ADDENDUM TO DRAFT CLOSURE PLAN
RIDGEFIELD BRICK AND TILE SITE
RIDGEFIELD, WASHINGTON

July 15, 1983*

This Addendum has been prepared to address comments on the subject draft closure plan contained in the August 4, 1983 letter from the Washington Department of Ecology to Pacific Wood Treating Corporation. This Addendum was prepared by Sweet, Edwards & Associates, Inc., Kelso, Washington and Patrick H. Wicks, Redmond, Washington at the request of Pacific Wood Treating Corporation.

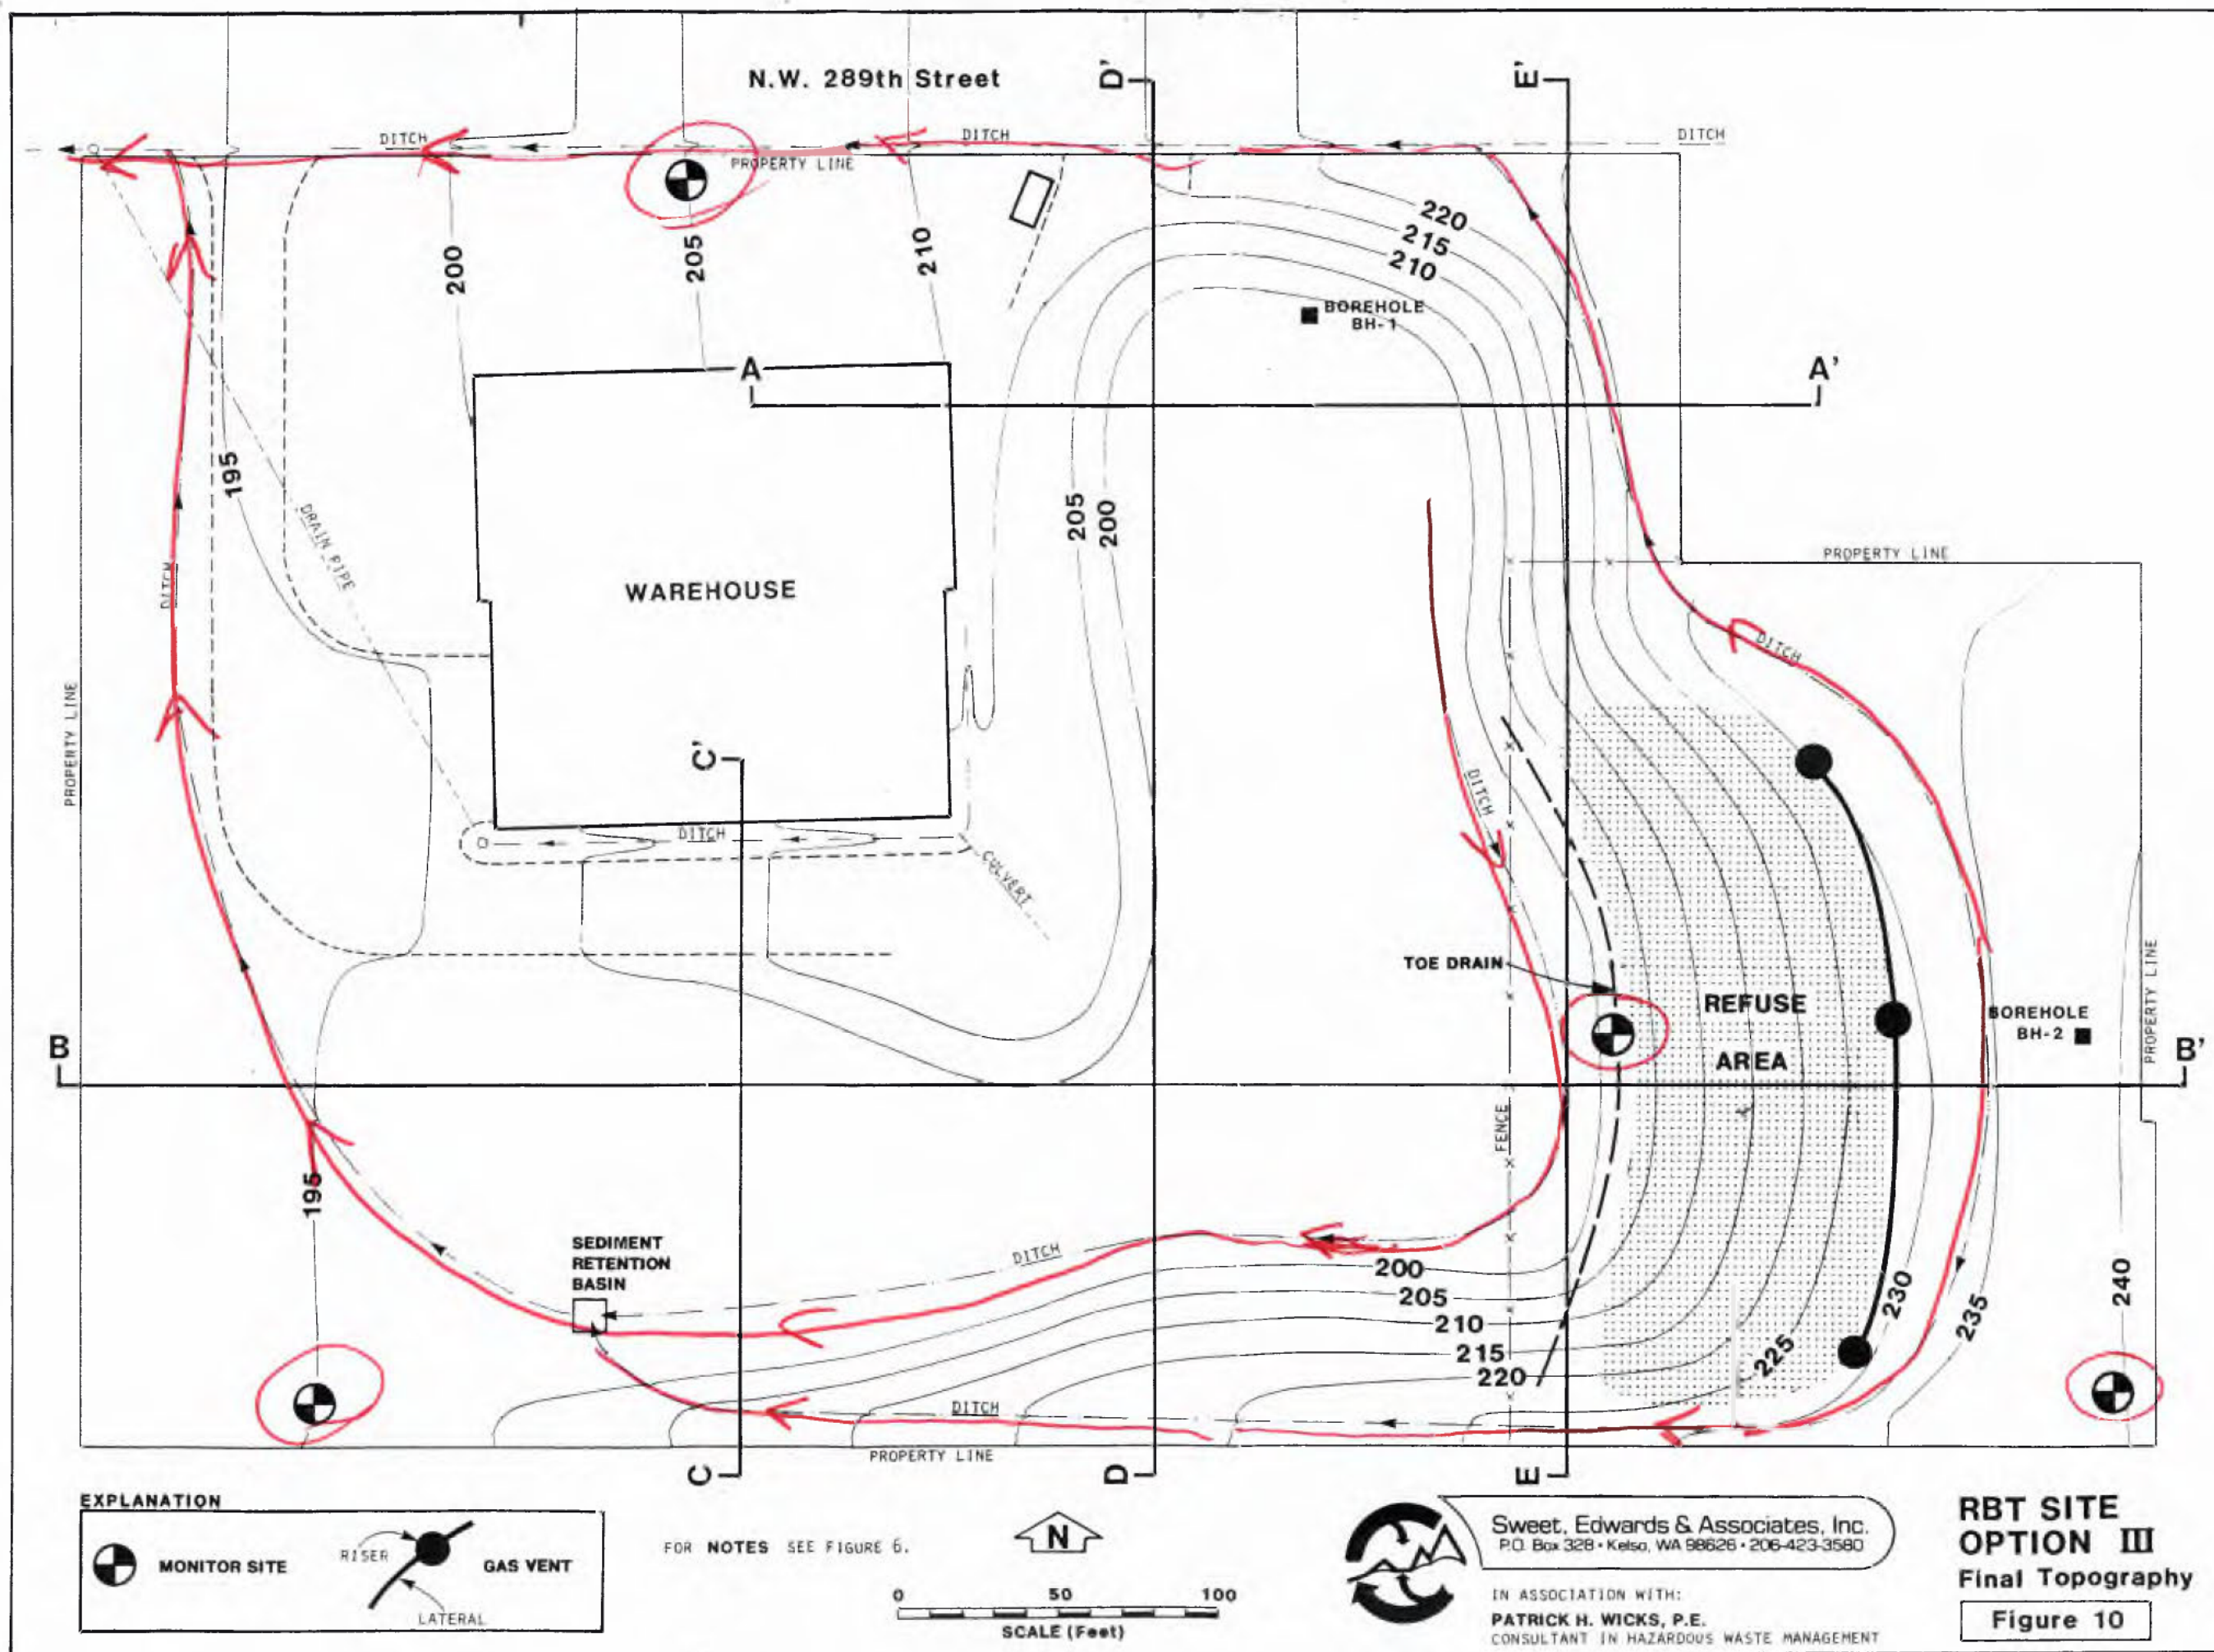
2. Toe drain and lysimeter locations were chosen to comply with the "waste management area. . . described by the waste boundry (perimeter)" under 265.91 as well as downgradient attenuation of any contamination. Specific locations have been adjusted as per the August 17, 1983 meeting agreement, see attached Figure 10. To the best of our knowledge, there is no regulation regarding the installation of lysimeters.

Figure 11

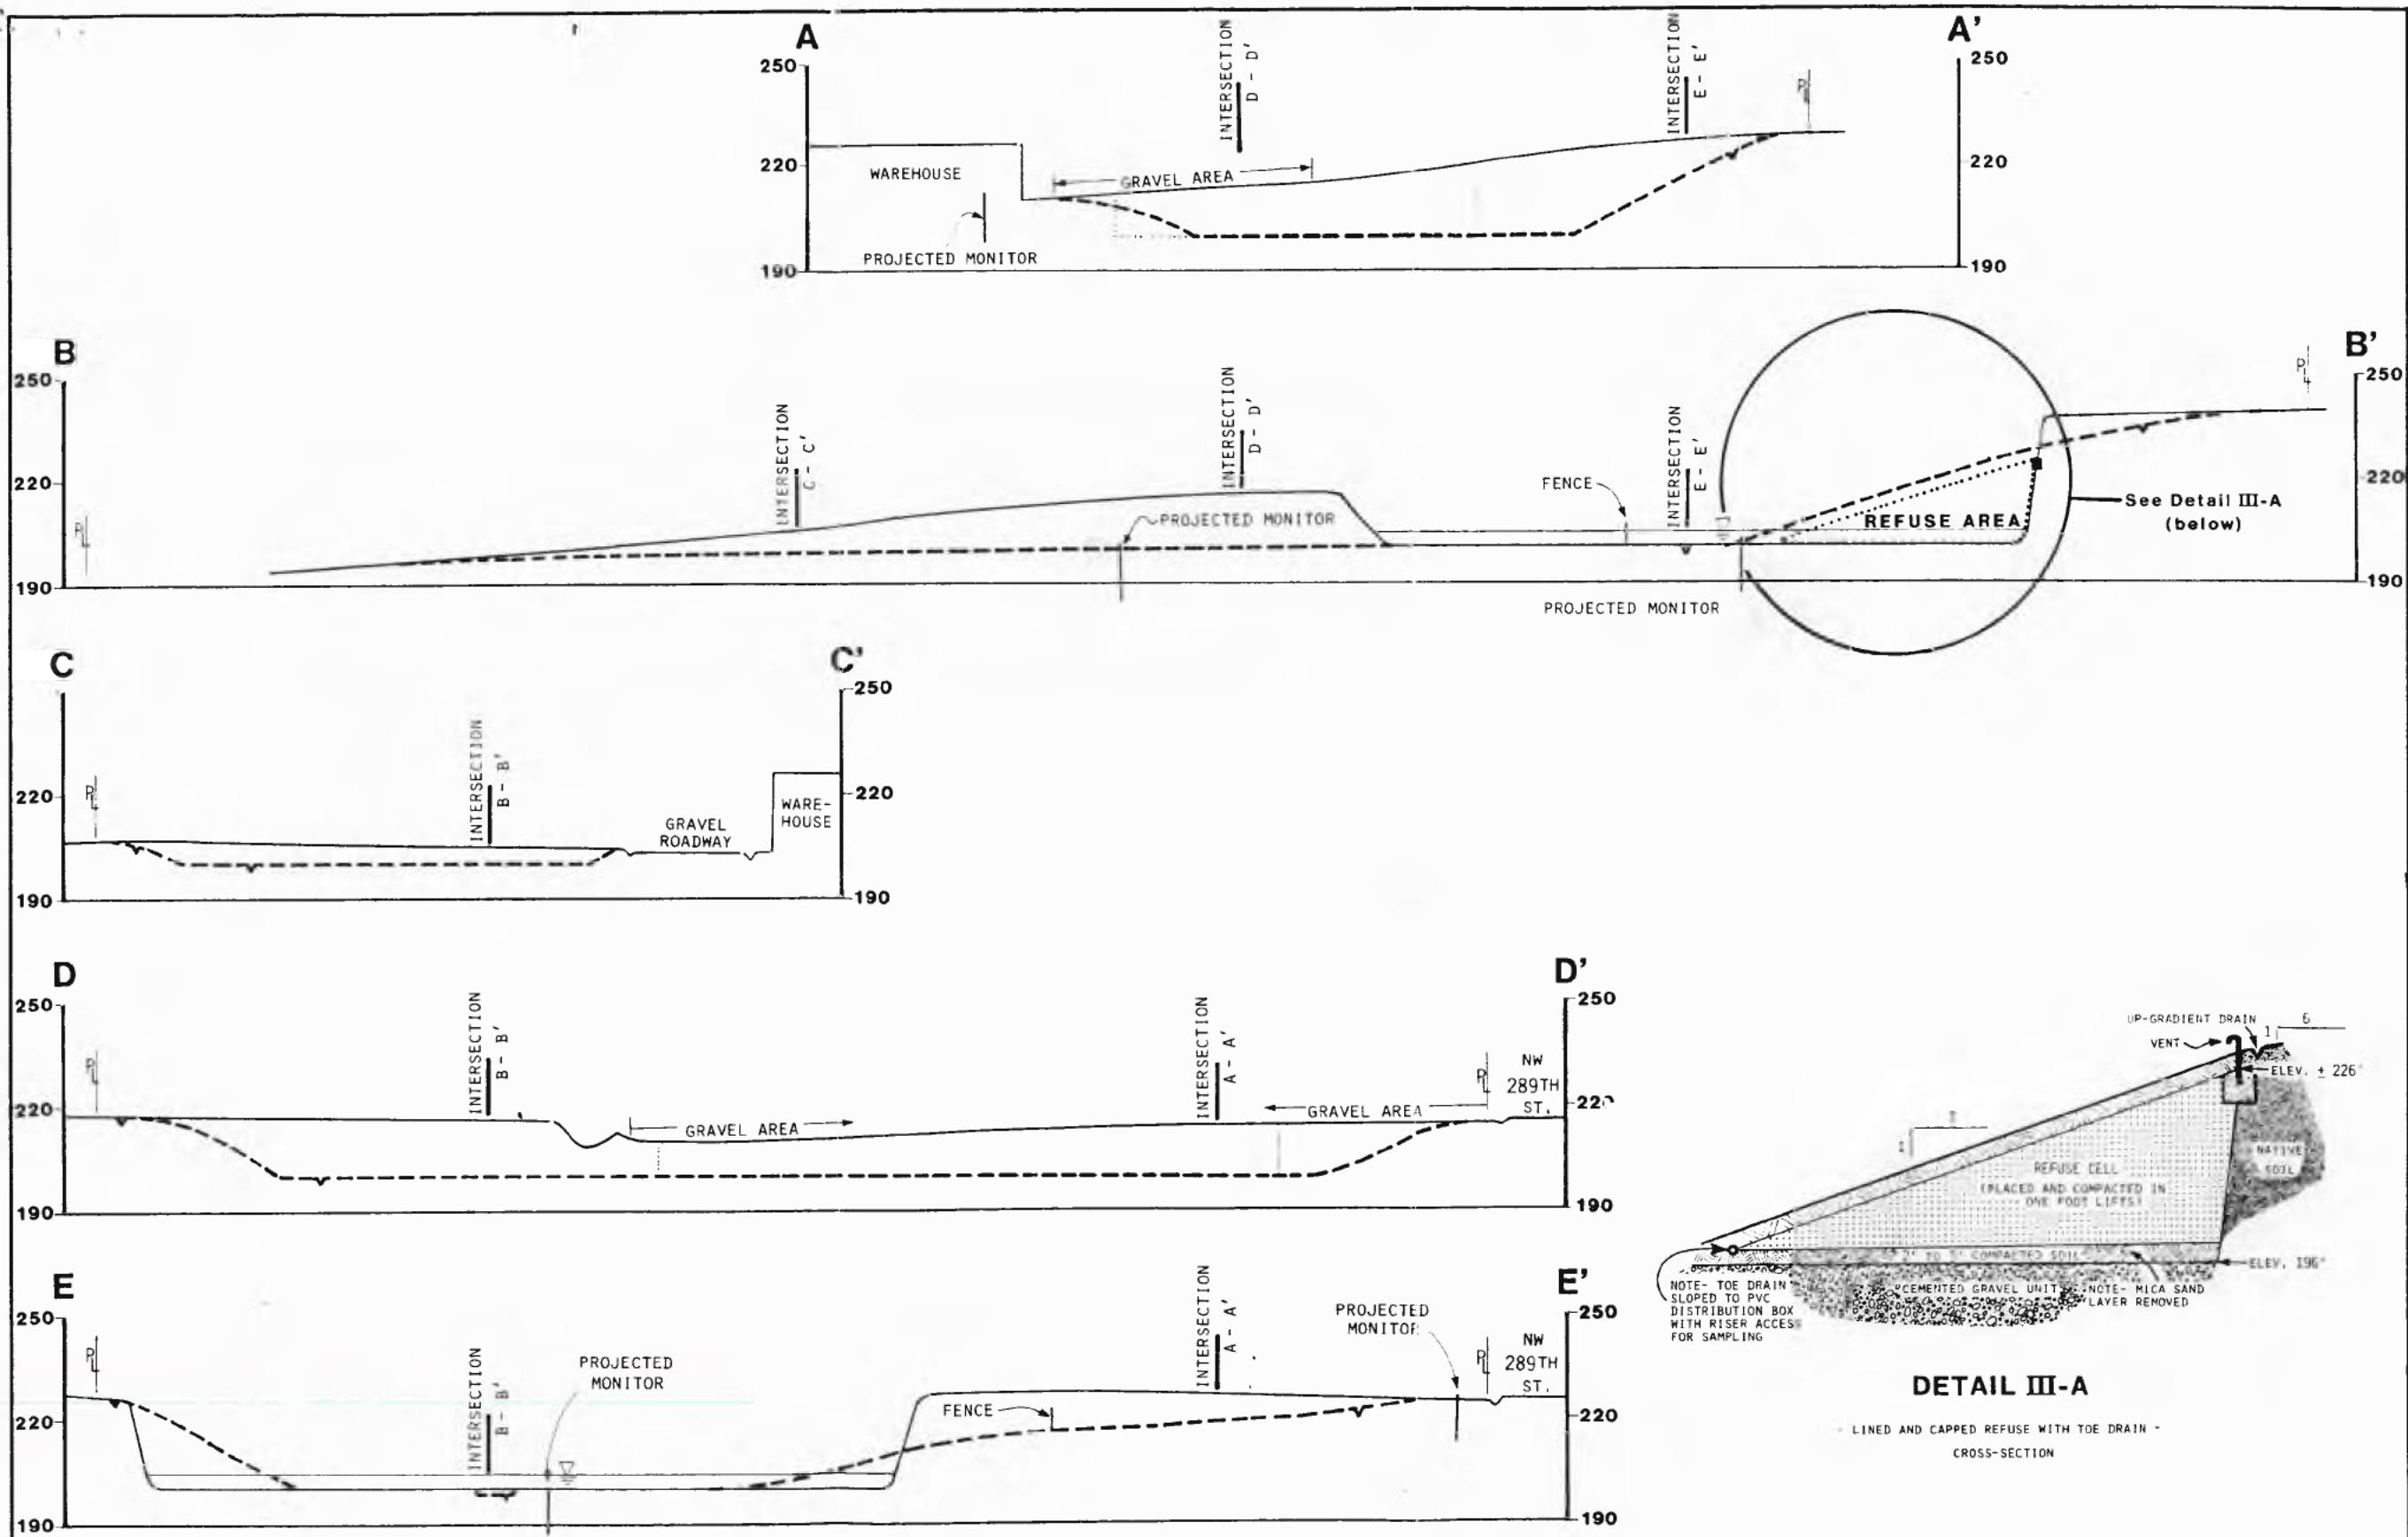
5. Detail III-A on page 28 of the draft closure plan was not clear in showing the relationship of the toe drain to the refuse cell. The toe drain will in fact be placed immediately adjacent to and in contact with the toe of the refuse cell to facilitate efficient collection of any leachate perching on the bottom layer and migrating to the drain, see modified Figure 11.

Figure 14

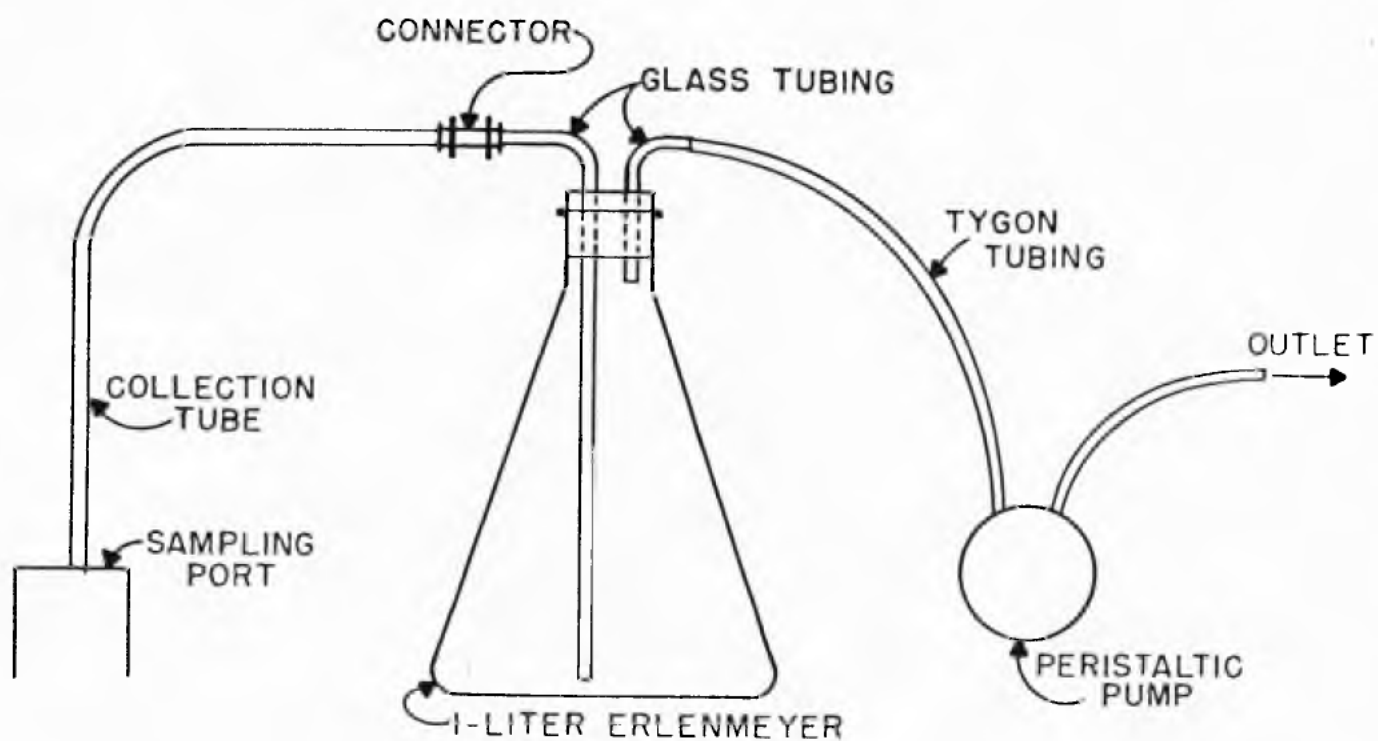
- 3b. One pore volume from the lysimeters or sampling port will be pumped to waste. Then, during sampling of the toe drain and the lysimeters, a system as shown on the attached Figure 14 will be employed. The dedicated tubing from the lysimeter or toe drain port will be attached to an Erlenmeyer flask. Pumping through a second tube from the flask or by pressure introduction into a second dedicated tube through the lysimeter will force the sample into the flask. If the sample is not turbid, it will then be transferred directly to the laboratory bottles. If it is found that the sample is turbid, it will be field filtered using a 0.45 micron filter as it is transferred to the laboratory bottle.
